2NSW-114 (sheet 1 of 2)
Upper Containment Ventilation
Unit 2 Return Line

POUR/ZONE No. 1.15	FLOW DIAGRAM 2-S116A
REQUIRED COMPLETION DATE	Q.S.L. 04
FABRICATED BY TUBECO	WELD PROCEDURE
NPS DESIGNS INC. NEW YORK, N.Y.	LIVSEY & COMPANY, INC. INDIANA & MICHIGAN ELECTRIC CO. DONALD C. COOK NUCLEAR PLANT
FABRICATOR NOTE: FABRICATION MUST CONFORM TO LATEST A.E.P. ARRGT. DWGS.	DWN: JG. DATE: 9/78 CD: LdB DATE: 9/78 ISSUED REF. DWG. 2-5497
	AUXILIARY BLDG. DWG. NO. 2-NSW-114 SH. 1 OF 2 REV. 6

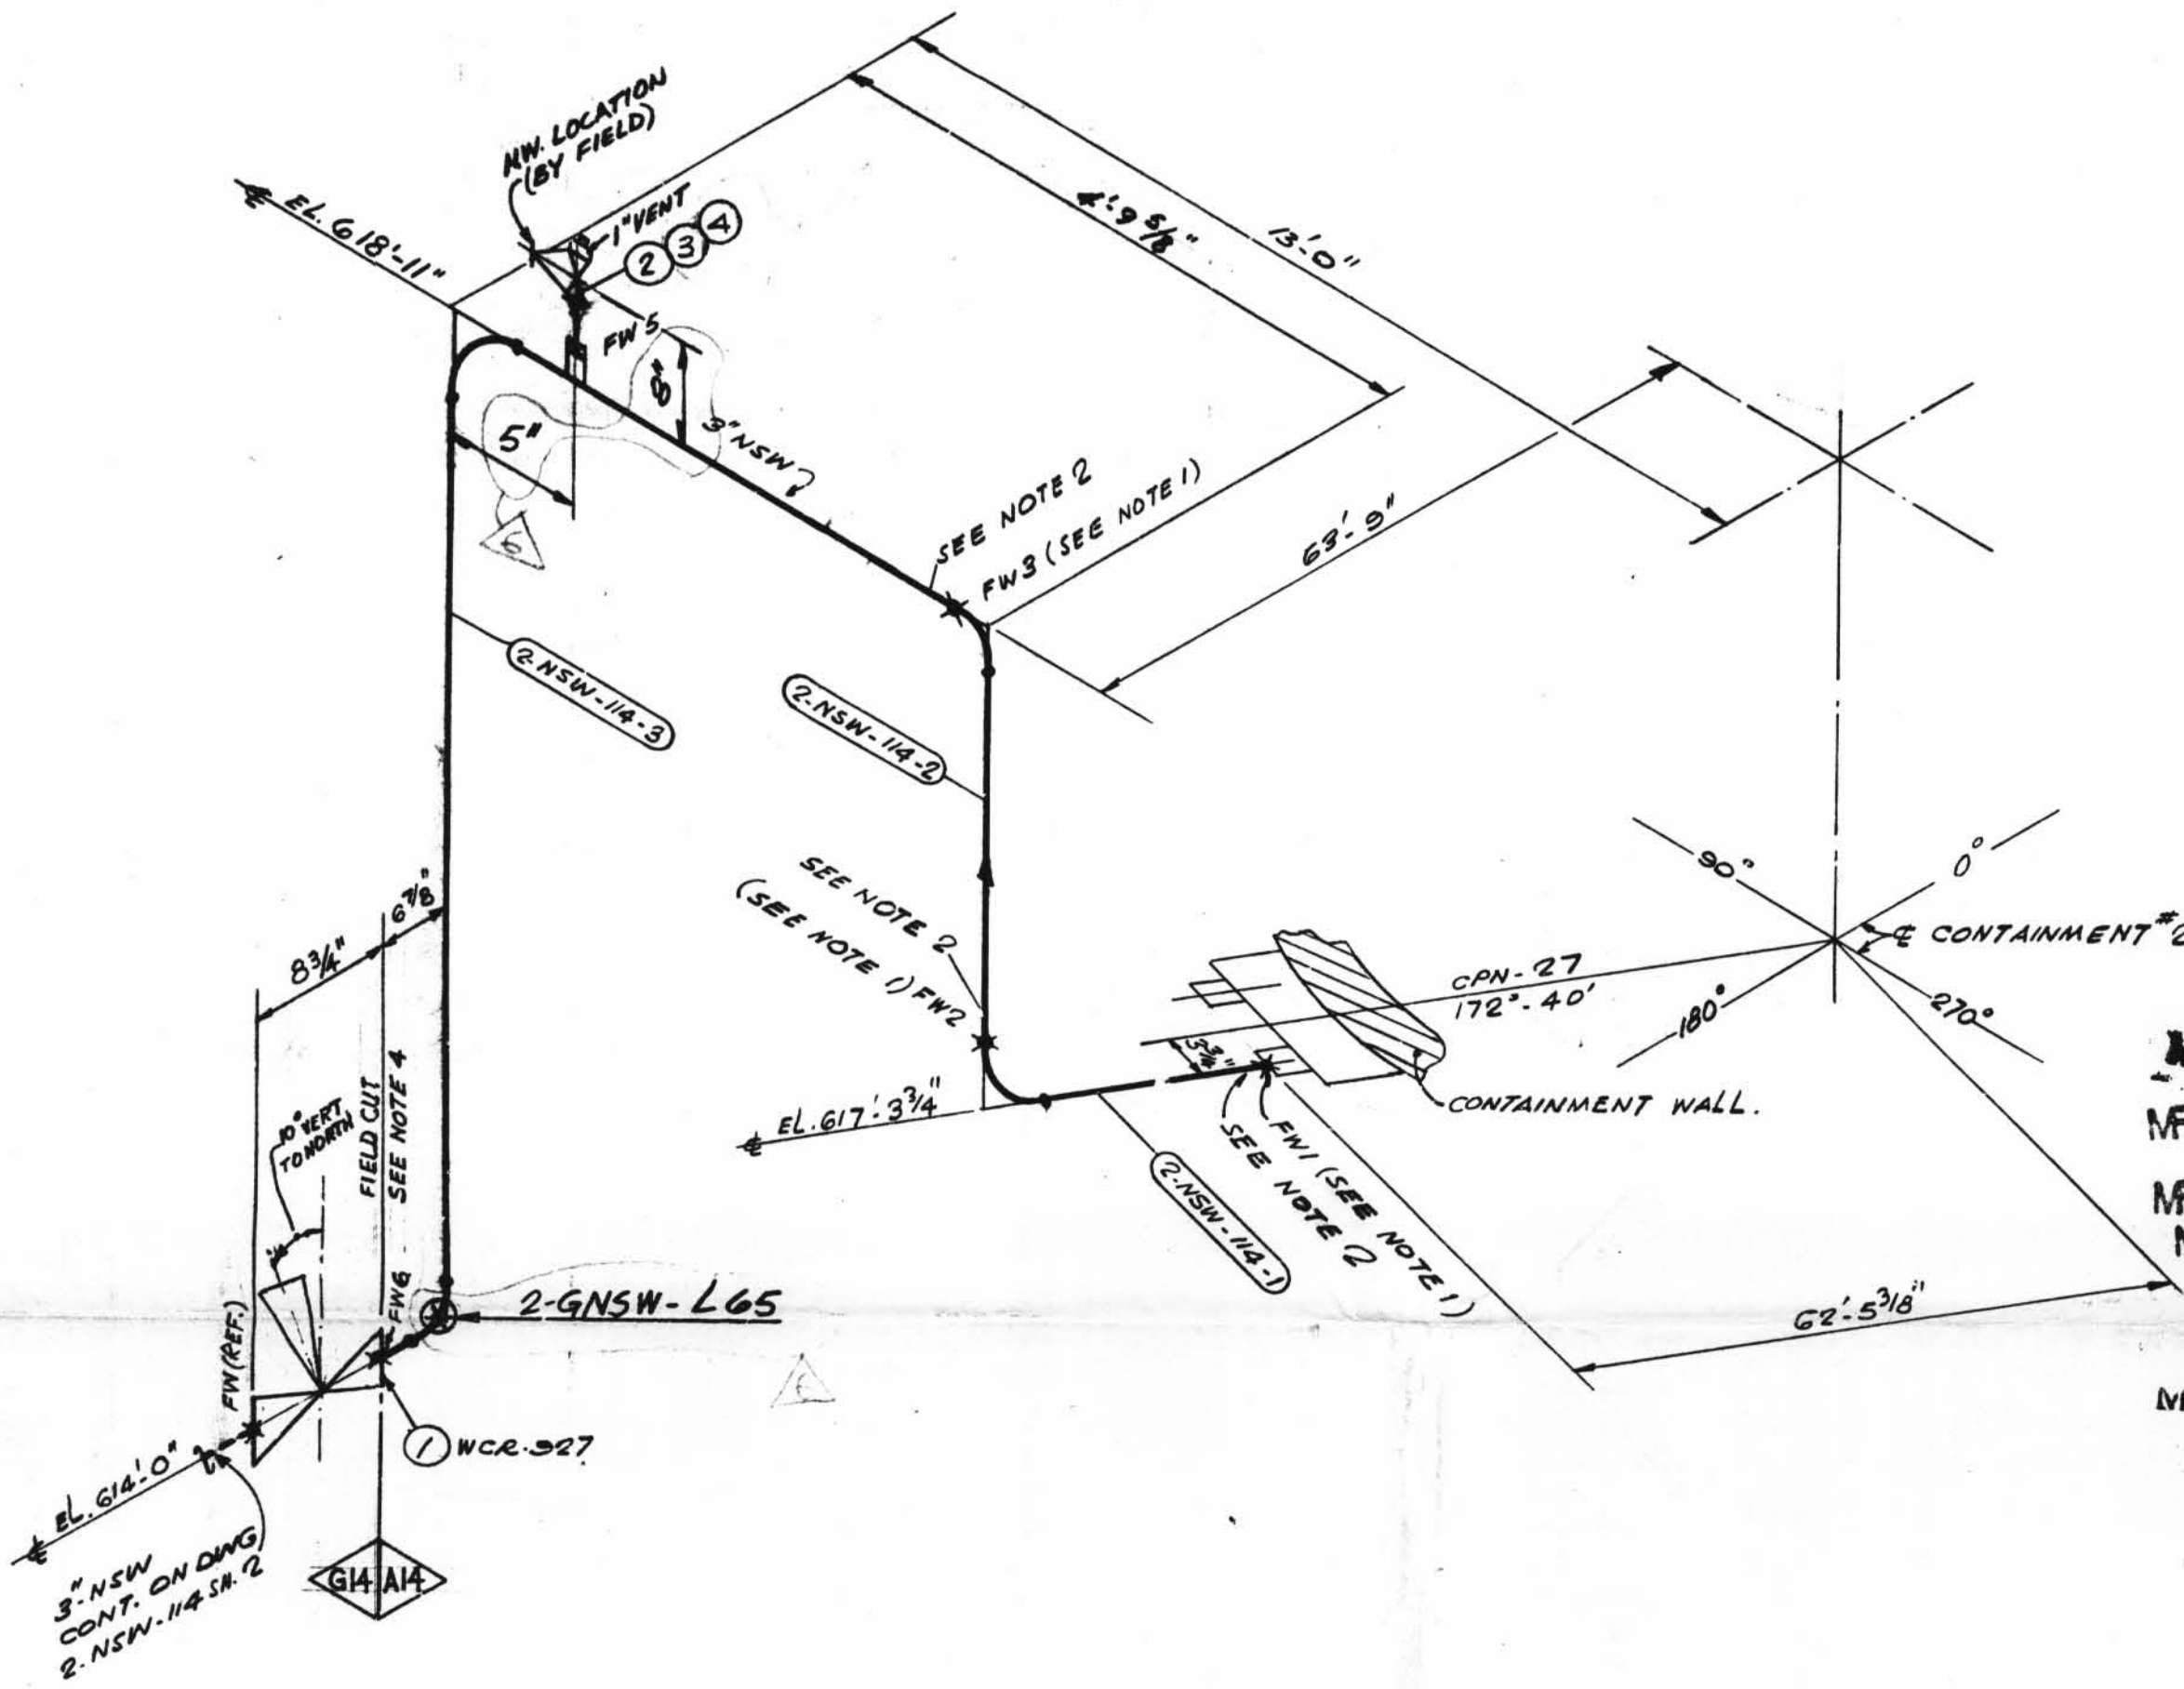
NO.	DATE	DR	CHK	DESCRIPTION	REMARKS
1	1/28/78	DR	B.R.	REVISED BY AEP DESIGN: PER RFC-DC-12-671: ADDED; 1" VENT VALVE NO Y-100723.	ACTION REQ'D.
2	2/1/78	DR	B.R.	PER RDM-MC-022 VA Y-100736 WAS Y-100723	
3	2/1/78	DR	B.R.	PER RFC-DC-12-2549, ADDED PIPE SPEC. G-14 DIM. FIELD WELD BOX, NOTES 4 & 5, FW-6. REVISED ITEM No. 1 W/B/M.	FIELD ACTION REQ'D.
4	10/14/78	DR	B.R.	PER RFC-DC-12-2549 ROTATED ACTUATOR OF VALVE WCR-927 TO 10° TOWARD NORTH.	FIELD ACTION REQ'D.
5	5/1/79	DR	B.R.	PER RFC-DC-12-2549 ADDED RED. INSERT & PLUG TO ITEM 2 & 3.	
6	7/21/80	DR	B.R.	TO REFLECT AS-FOUND CONDITIONS FOR RFC-DC-12-3010 PER FWR# 759 REV. 1 ADDED DIMS., SUPPORT MARK NO. & SUPERSEDES HGR. ISO #12-GNSW-114 SH.# 1.	ACTION REQ'D.
